**PORT OF BROOKINGS HARBOR**  
**Special Commission Meeting**  
**Thursday, February 4, 2021 • 9:00am**  
**Teleconference / Meeting Room** *(limited capacity)*

**DATE:** February 4, 2021  
**RE:** Fuel Dock Project Changes  
**TO:** Honorable Board President and Harbor District Board Members  
**ISSUED BY:** Gary Dehlinger, Port Manager

**From:** Jack <emc@emcengineersscientists.com>  
**Sent:** Wednesday, February 3, 2021 8:41 AM  
**To:** Gary Dehlinger-Port of Brookings Harbor  
**Subject:** Fuel Dock Access Pad

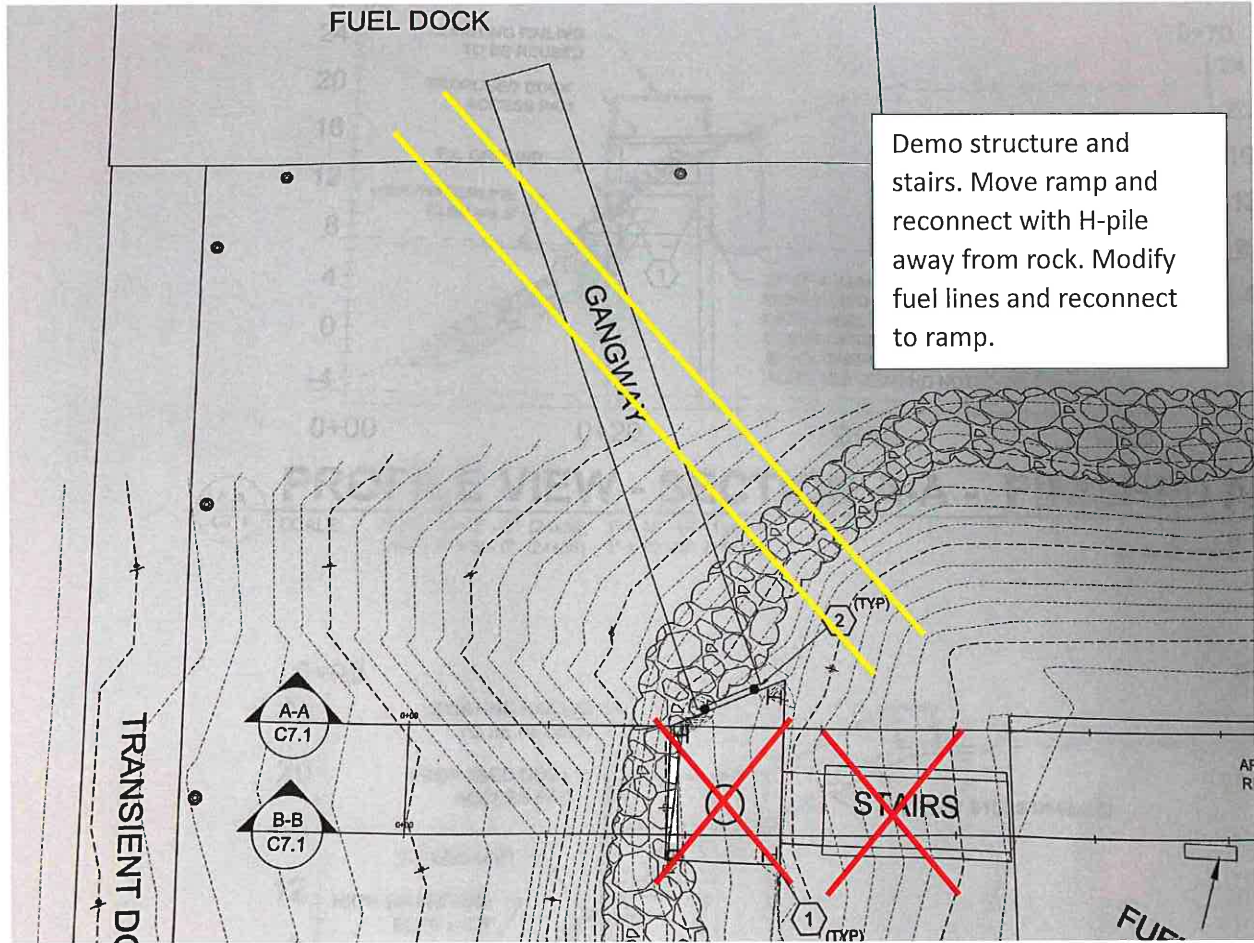
Upon removal of the top plate, sidewalls and bottom plate of the concrete fuel dock access pad we found another, subsurface plate (as much a three feet thick in some places) beneath the bottom plate. That plate was pinned to riprap, which was discovered to underlay the entire pad. This may explain why those that constructed the pad some thirteen years ago had elected not to conform to the engineered drawings.

So now we know that the entire fuel dock access pad was placed on a riprap foundation. The design proposed for this project is prescribed on independent support from driven columns (H-Piles), to avoid the threat of “daylighting”, that is: the shifting of the embankment, primarily due to storm and groundwater pore pressure, combined with tidal scour.

We find that we cannot drive piles in any nearby area to provide the necessary four-pile support for a concrete pad close enough to provide access to the fuel dock.

However, during discussions with Port Management, the question was posed as to whether an access pad was really necessary, since access to the fuel dock was the function of the pad, if another access route could be found. The primary advantage of the pad was to reduce the slope of the gangway (maximum at low tide).

So if we simplify the design of the gangway by locating two supporting H-piles somewhat away from the edge of the embankment, closer to the top floor elevation, we can provide access, though perhaps at somewhat a greater slope.

An estimated increase/decrease in gangway slope can be estimated. The top concrete pad (above the steps) is fixed to about +22' MLLW elevation. The top of the fuel dock access pad (now removed) was at about +16' MLLW. Given a lowest low tide of -2' MLLW, and adding 2 feet to top of Fuel dock decking, we have a maximum drop from the pad of 16'. The length along the top of 50' gangway from the north edge of access pad to the edge of the fuel dock is about 44.5'. Therefore the maximum gangway slope in % is about 38.4% (approx.. 21 degrees). If a 60' gangway was used without a pad, it looks like we can place on-shore connection

to H-piles at about +20' MLLW elevation. The resulting elevation difference would be 20 feet, and the resulting slope about 37.4%.

So, given the placement as described, there would be no significant change in slope by eliminating the fuel dock access pad.

It was suggested during the above-described discussions that a 60' gangway, presently planned for the work dock access, could be exchanged with the present fuel dock access pad 50' gangway.

- **Recommended Motion:**  
Motion to approve eliminating the concrete access structure and relocate the ramp and utilities to the proposed location. Project monetary changes will be reconciled at a later date.
